client: ARROWSMITH BRUNSWICK SQUARE LTD.		date: JUNE 25	
project: BRUNSWICK MILL DEVELOPMENT PHASE 1		scale: SCALE 1:10 @A3	drawn by: TC
title: MAIN ROOF BUILD-UP, PARAPET AND LIFT OVERRUN		drawing number: L(27) 101	
status: CONSTRUCTION		job number: 0586	revision: C2

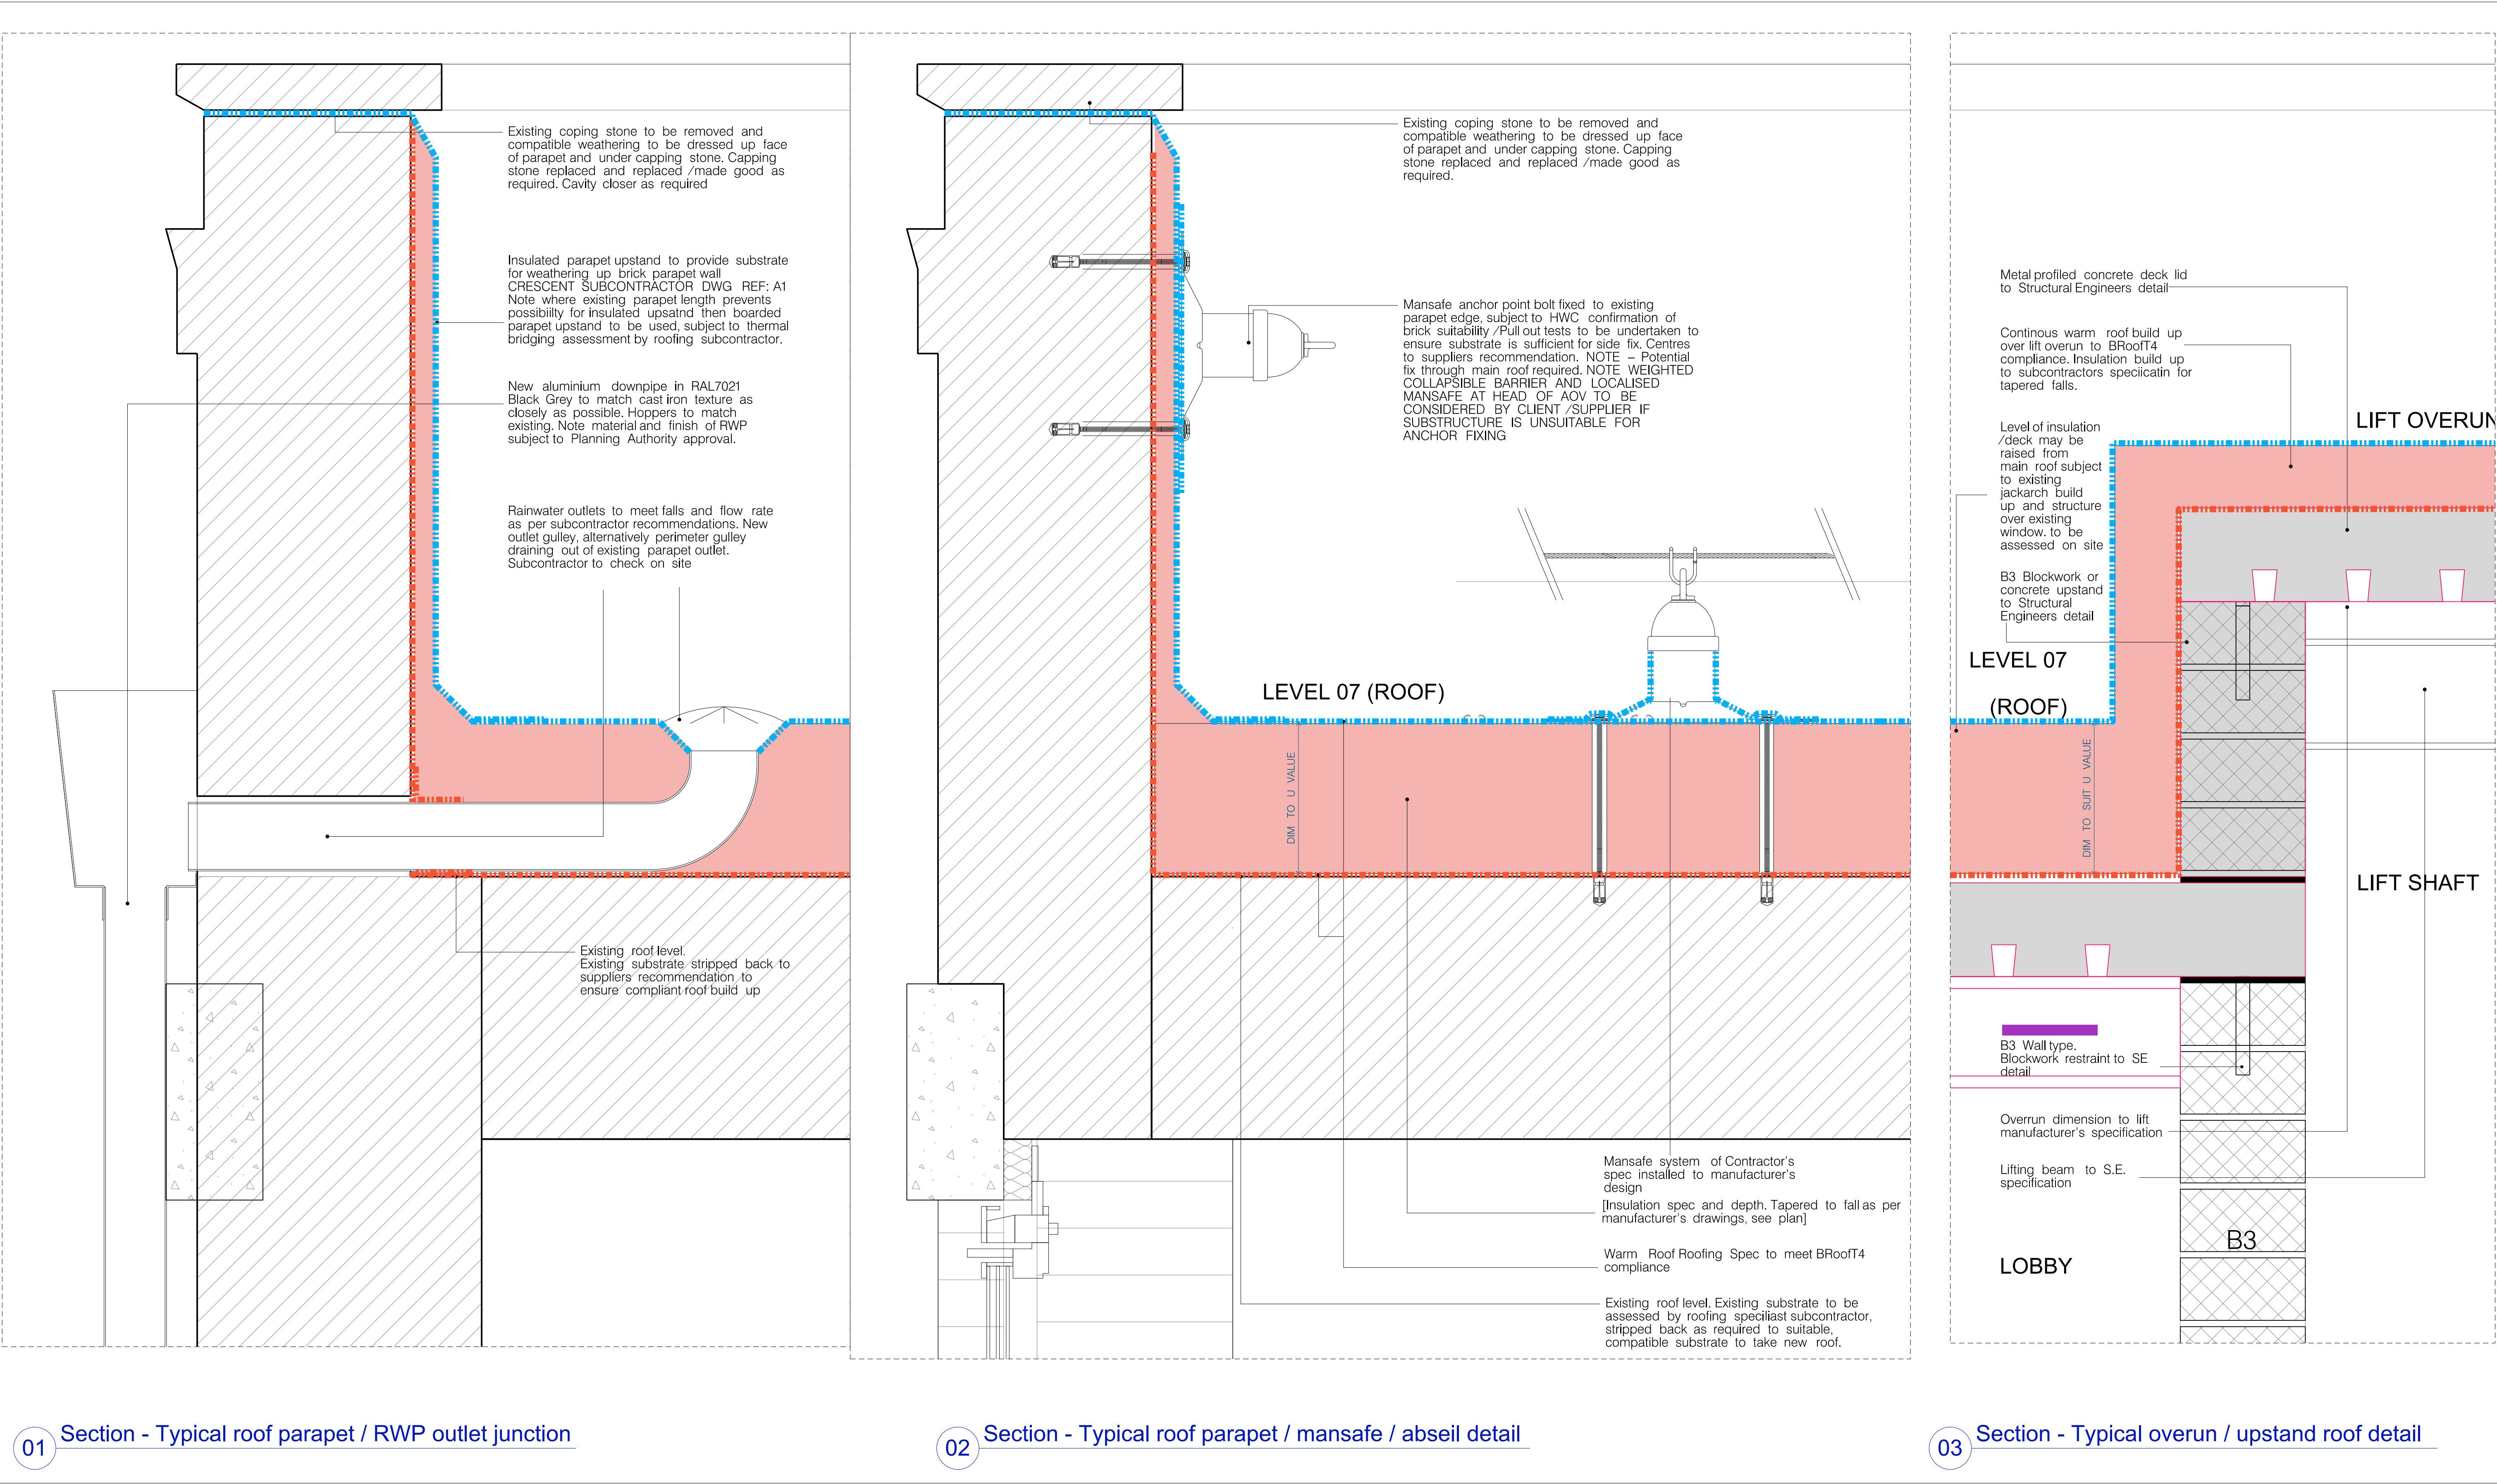
hodder+partners		revisions + notes:		ROOF Information for design Intent. Refer to Roofing Specialist subcontractor information Falls to be designed to a minimum 1:60 to achieve a minimum 1:80 on site across all roof levels where applicable Tapered insulation design to be coordinated with aforementioned upstands, RWO locations, penetrations and overuns. Refer to NBS specification with regards J31 and J41 roof weathering system build ups - similar approved. Location of applications denoted on each plan. Refer to HOD (27) series drawings for typical roof build up details. Refer to (31)series drawings for rooflight / roof drawings. Refer to L(20)207 AND L(20)1071 - 1073. FOR AOV SCHEDULE REFER TO S(31)002
SGI Studios		P01 21.05.25	ISSUE SHOWING MANSAFE AND ANCHOR POINT	
1 Kelso Place		C01 23.06.25	PRELIMINARY CONSTRUCTION ISSUE	
Manchester M15 4LE		C02 17.11.25	DETAIL AMENDED TO S/C DETAIL BOARDING EXTENDED TO UNDERSIDE OF PARAPET AS DISCUSSED WITH PLANNING AUTH (17.11.25)
